# MEMORANDUM

SUBJECT: **Peer Review of FB Environmental Associates A  
Regulatory, Environmental, and Economic Analysis of  
Water Supply Protection in Auburn, Maine dated October  
2021 and the supplemental Lake Auburn Model Technical  
Memorandum dated August 1, 2022**

DATE: **December 5, 2022**

**Figure 3-1.** Map of groundwater contours developed by E.C. Jordan Co. (1990) (left) compared to map of updated watershed boundary (right). The dotted red circle is provided for ease of reference between the two maps.

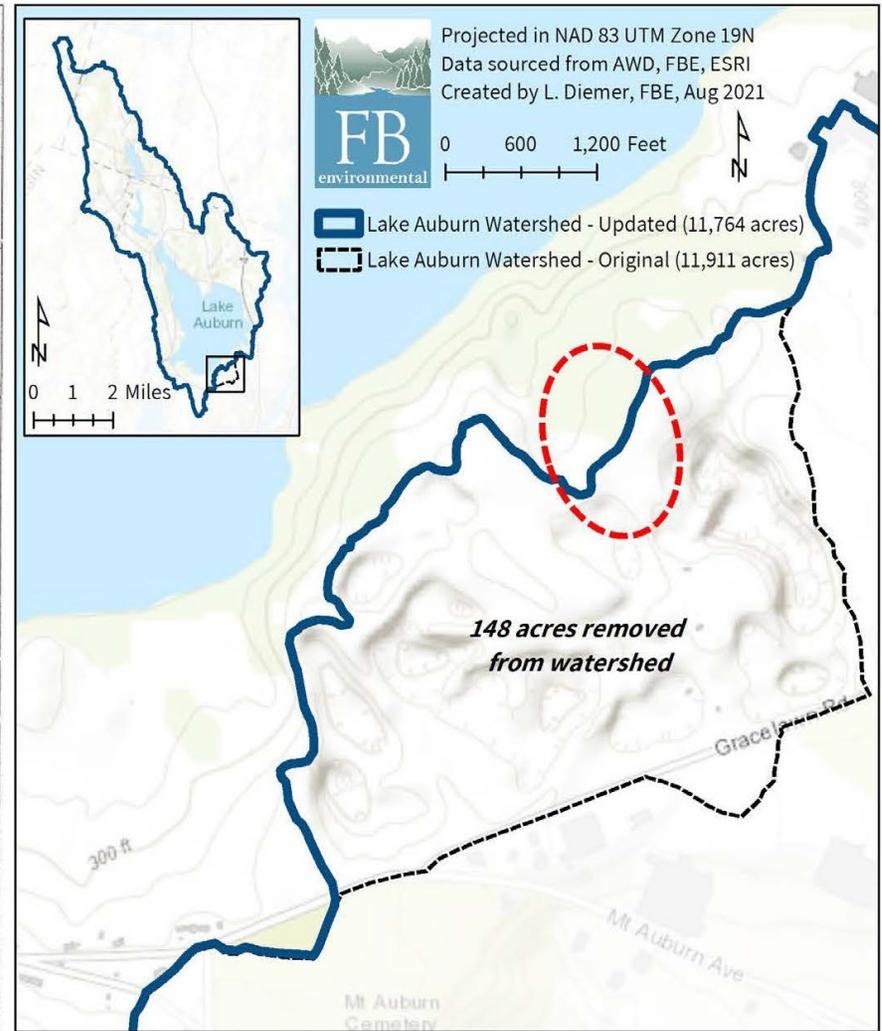
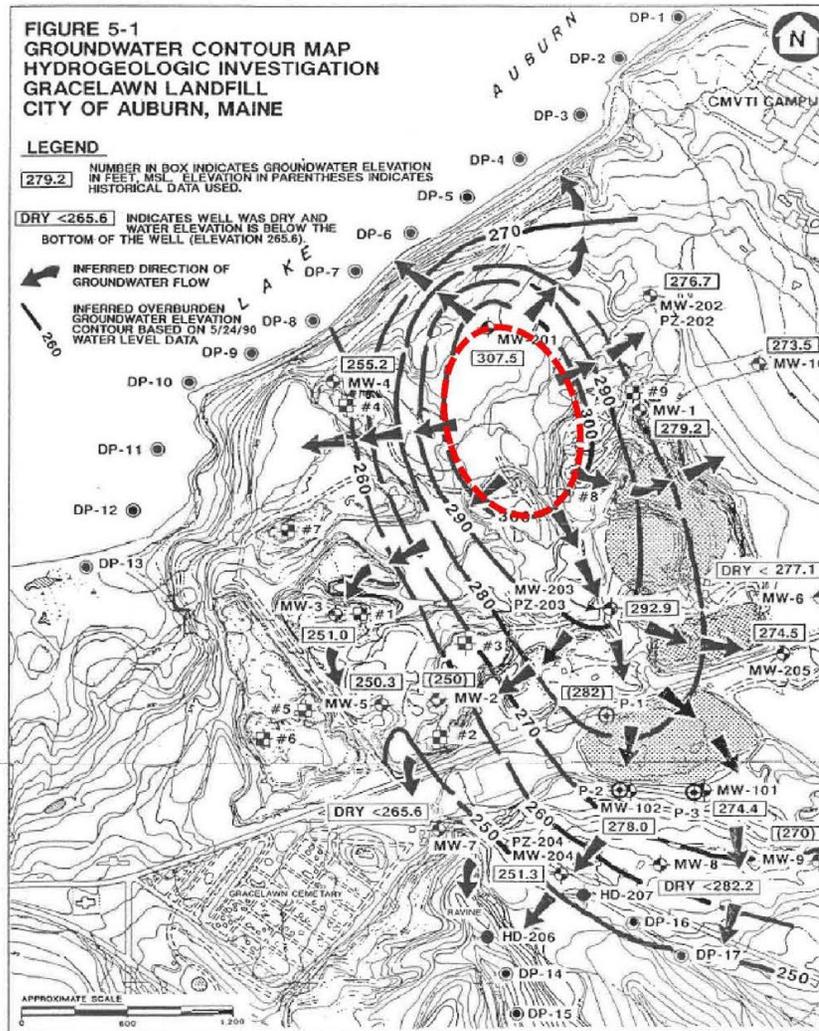
FBE Figure 3-1 (**Attachment B**) shows groundwater contours in the vicinity of the sand and gravel operations and former City of Auburn landfill along Gracelawn Road. The contours reveal a localized groundwater mound, where the groundwater is higher than the surrounding area, causing it to flow in all directions away from the mound, rather than following expected regional groundwater flow patterns towards the lake.

CEI cautions the City from discounting this area from the watershed entirely, particularly under a future development scenario. Development of the land surface can change the existing infiltration rates, decrease depth to groundwater, alter flow rates and patterns and potentially impact localized groundwater conditions, potentially impacting the water boundary in this area. This requires a

more detailed evaluation of potential development scenarios and their impact on both localized groundwater and surface water runoff.

FBE recommended that 148 acres of the watershed in the Gracelawn Road area be removed from the watershed. This was based on hydrogeologic studies of the sand and gravel operations and former City of Auburn landfill along Gracelawn Road, which showed groundwater to flow away from Lake Auburn. CEI did not review the referenced hydrogeologic studies as part of this evaluation. The only information provided was in the October 2021 FBE study, which includes Figure 3-1 showing the mapped groundwater contours taken from one of the hydrogeologic studies. The groundwater contours reveal a localized groundwater mound, where the groundwater is higher than the surrounding area, causing it to flow in all directions away from the mound, rather than following expected regional groundwater flow patterns towards the lake. However, CEI cautions the City from discounting this area from the watershed entirely, particularly under a future development scenario. Development of the land surface can change the existing infiltration rates, decrease depth to groundwater, alter flow rates and patterns and potentially impact localized groundwater conditions, potentially impacting the watershed boundary in this area. This requires a more detailed evaluation of potential development scenarios and their impact on both localized groundwater and surface water runoff.
